# WANG FIELD CHANGE ORDER

FCO NO.  
1004

Equipment Affected 2280 AND 6580 PHOENIX DRIVES (BLOCK POINT 3 AND BELOW)  
Class NEXT CALL FCO Kit # 728-0018-25 Page 1 of 9  
Org. Code III.A.7 FCO Doc. # 729-1090 Approval Date:  
Est. Install. Time 45 MINUTES Ref. ECO # CDC# 33779 **JUN 28 1982**

To provide protection to heads and media in the event of severely restricted air flow or blower motor failure.

Figure 1. Views Showing Location of Wire to be Replaced for this FCO.

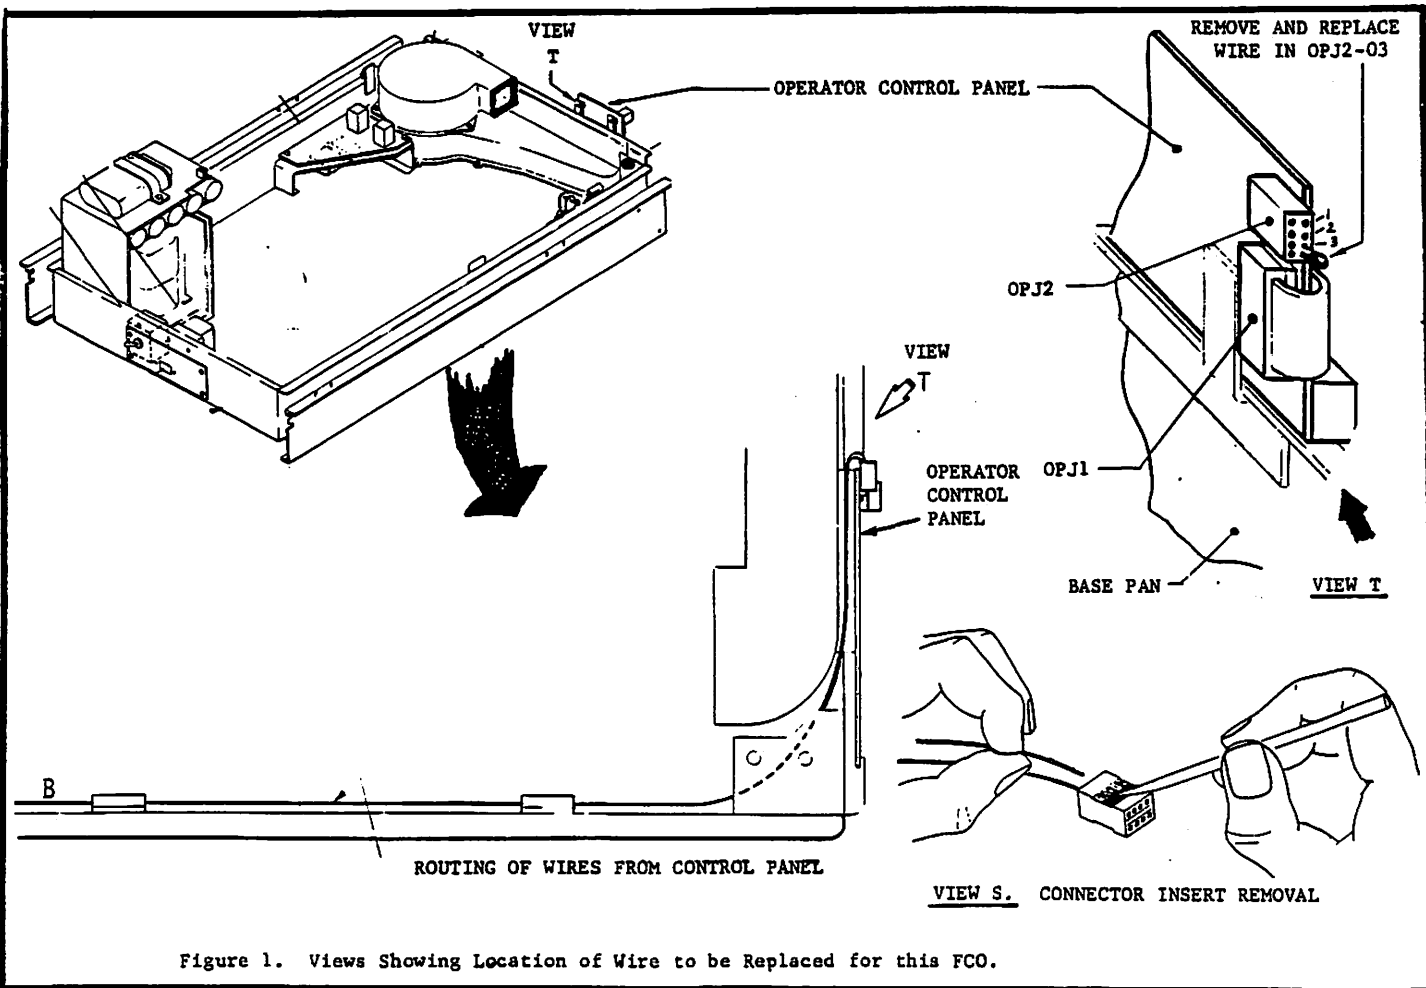
- F. Refer to Figure 1. Disconnect eight-pin connector OPJ2 from the operator control panel at the left front of the base pan. Extract terminal at OP02-03. Refer to View S, Figure 1. To extract terminal, lift retaining tab slightly using a narrow pointed object such as a small, very thin knife blade, and with a small pull force on the wire, slide the terminal from the connector body. Now refer to Figure 2. Disconnect opposite end of the wire at SW1-0C (deck down switch) located near the electronics module under the left side of the deck. Cut the ends of the disconnected wire and leave in the harness.

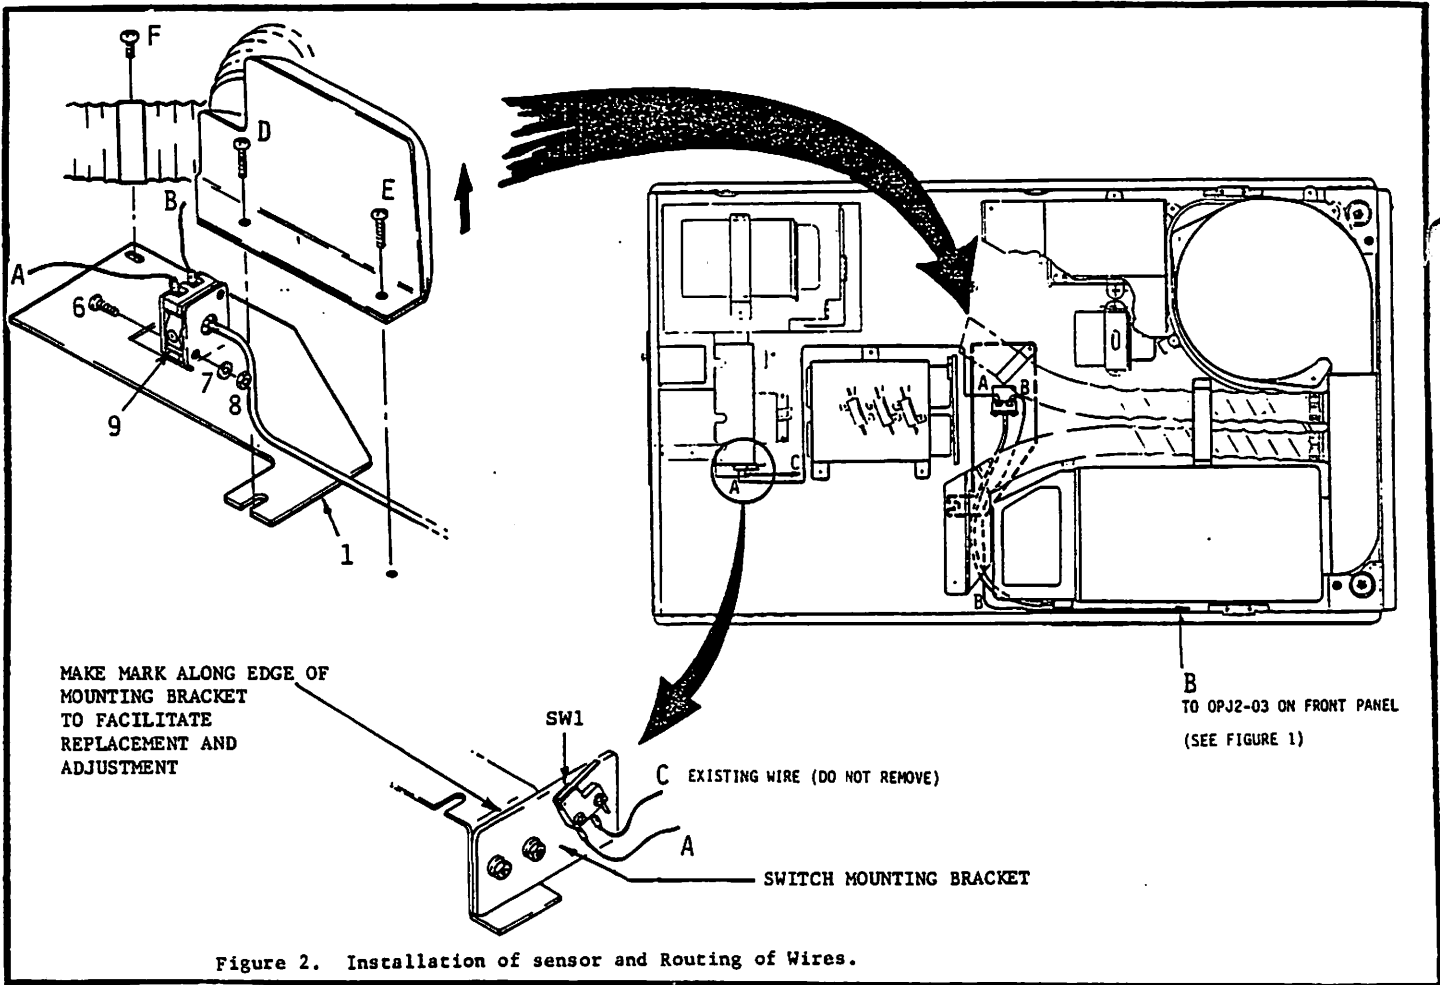
- C. Install Items 1-13 from FCO Pressure Sensor Kit (for listing of parts see Section 10 - MISCELLANEOUS) as described by this and subsequent paragraphs. Refer to Figure 2. Mount pressure sensor (Item 9) to the sensor bracket (Item 1). Fasten using machine screw (Item 6), washer (Item 7) and hex nut (Item 8). Be sure that spade lugs on sensor (Item 9) are mounted upward as shown in Figure 2.

- D. Refer to Figure 2. Loosen but do not remove the screws at D and E. Remove and save the screw at F.
- E. Install the sensor bracket (Item 1) with attached sensor (Item 9) in the base pan by sliding the bracket under the air deflector at Hole D. Reinstall the screw at F. Tighten the screws D and E.

- O. Refer to Figure 2. Install the end of the air tubing (Item 5) with the set screw onto the air tube (Item 4). Route the air tubing down to the base pan, around the absolute filter, under the air deflector and over to the pressure sensor (Item 9). Plug on to the stem of the pressure sensor.

Figure 3. Installation of Filter Fitting to Pick Off Air Pressure to Route to Sensor

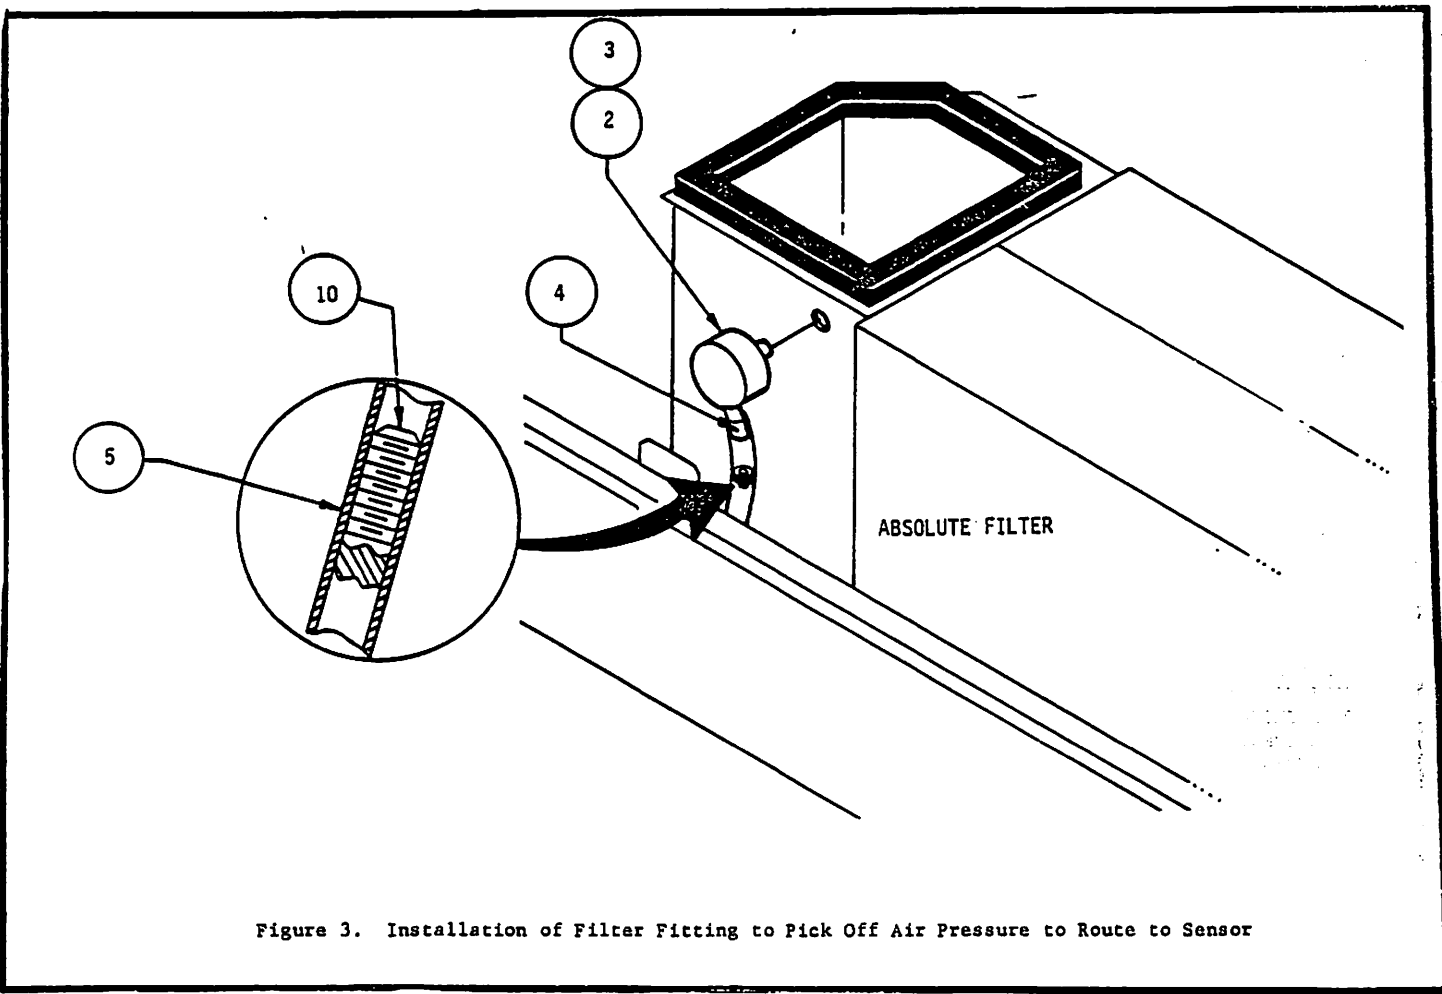
I. Refer to Figure 3 for steps involving items 2, 3, and 4. Insert O-ring (Item 3) into groove of filter fitting (Item 2). Press the O-ring to the bottom of the groove.

N. Refer to Figure 3. Insert set screw (Item 10) 1.00 + or - .12 inches (25.4 + or -3 mm) from one end of air tubing (Item 5).

DECK-IN-PLACE SWITCH

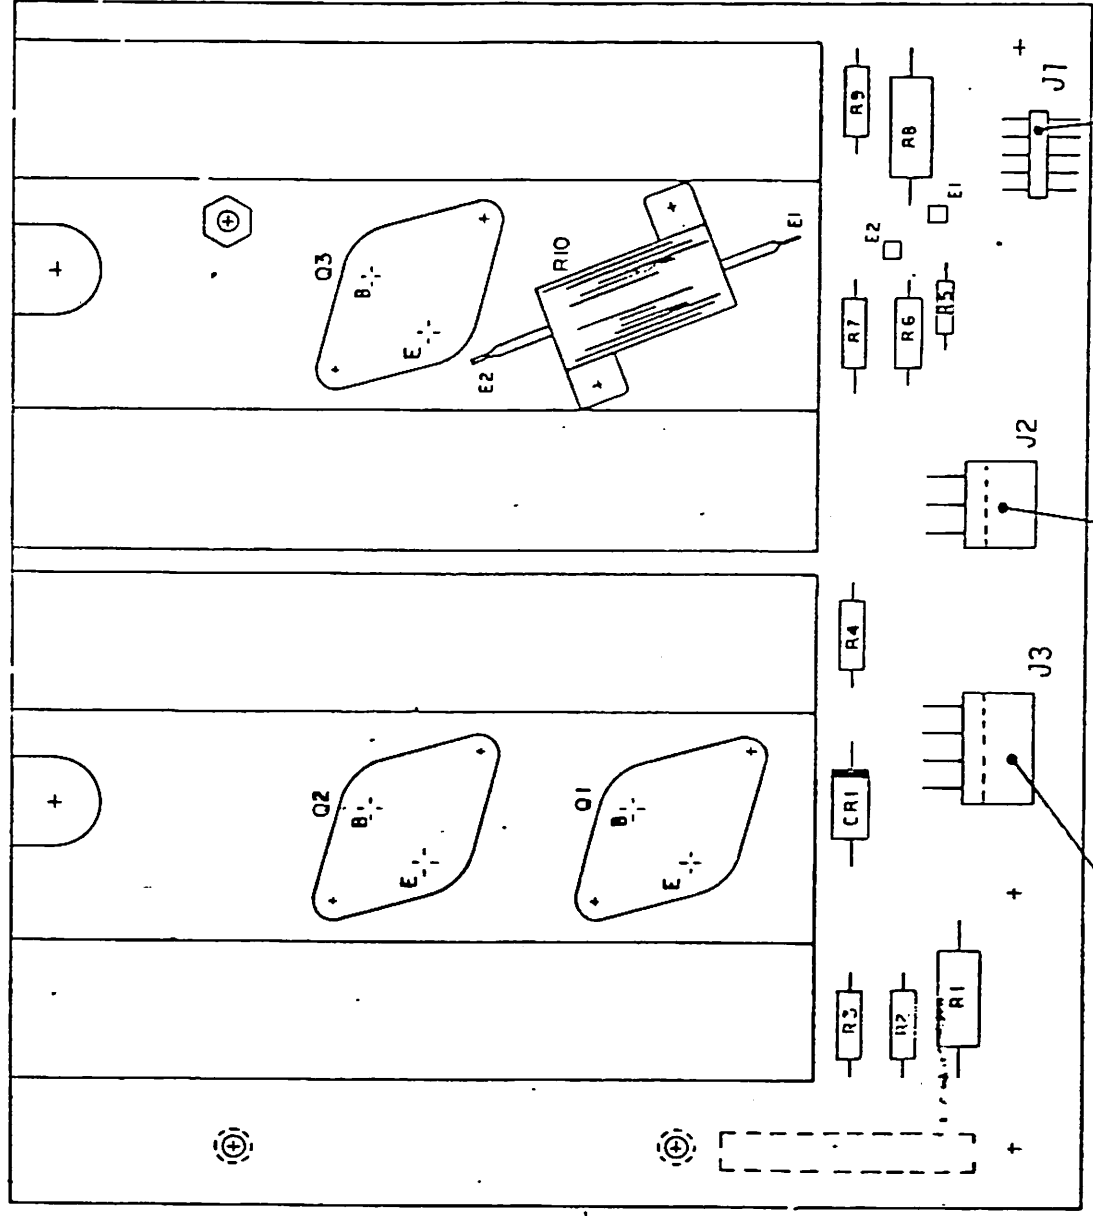
- (A) REPLACE CURRENT DECK-IN-PLACE MICRO SWITCH LOCATED IN THE BASEPAN WITH A MAGNETICALLY ACTUATED REED SWITCH MOUNTED ON THE COMPONENT BD. MAGNET USED TO ACTUATE THE REED SWITCH WILL BE MOUNTED TO THE BASEDECK ABOVE THE COMPONENT BD.
- (B) IMPROVES PRODUCT QUALITY AND RELIABILITY, REDUCES MTTR.
- (C) SERIES CODE FOUR DECK-IN-PLACE SWITCH IS NOT COMPATIBLE WITH PREVIOUS SERIES CODE UNITS.
- (D) PREVIOUS SERIES CODE SWITCHES ARE NOT COMPATIBLE WITH SERIES CODE FOUR UNITS.
- (E) REFER TO SERIES CODE FOUR PRODUCT MAINTENANCE MANUAL FOR NEW SWITCH ID.

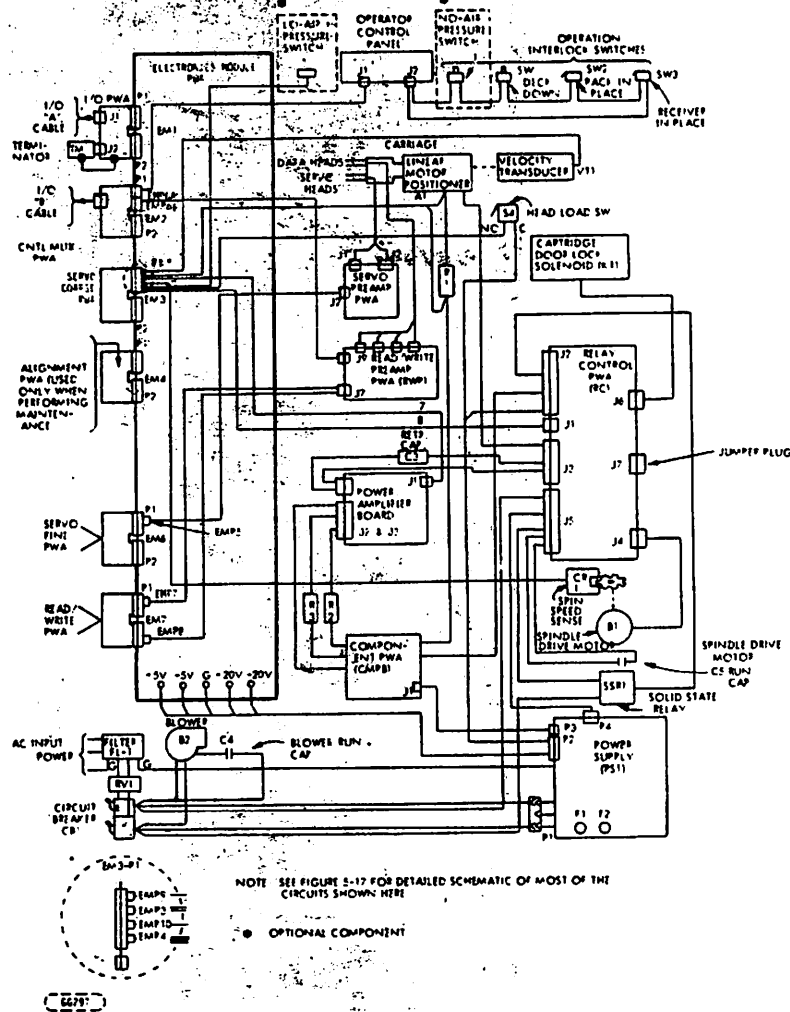
EXPLANATION:  
For an undetermined time, Logistics was stocking and shipping the Phoenix Spindle Drive Motor (WPN 726-6726, CDC P/N 77638604) with a 50Hz pulley instead of a 60Hz pulley. To identify which Spindle Drive Motors to purge, note the CDC part number stamped on the pulley itself. The following are the pulley part numbers:

Correct	60Hz Pulley	CDC Part Number - 75899707
Incorrect	50Hz Pulley	CDC Part Number - 75899706

60 Hz MOTOR WORKED

50/60 Hz MOTOR WOULD NOT WORK
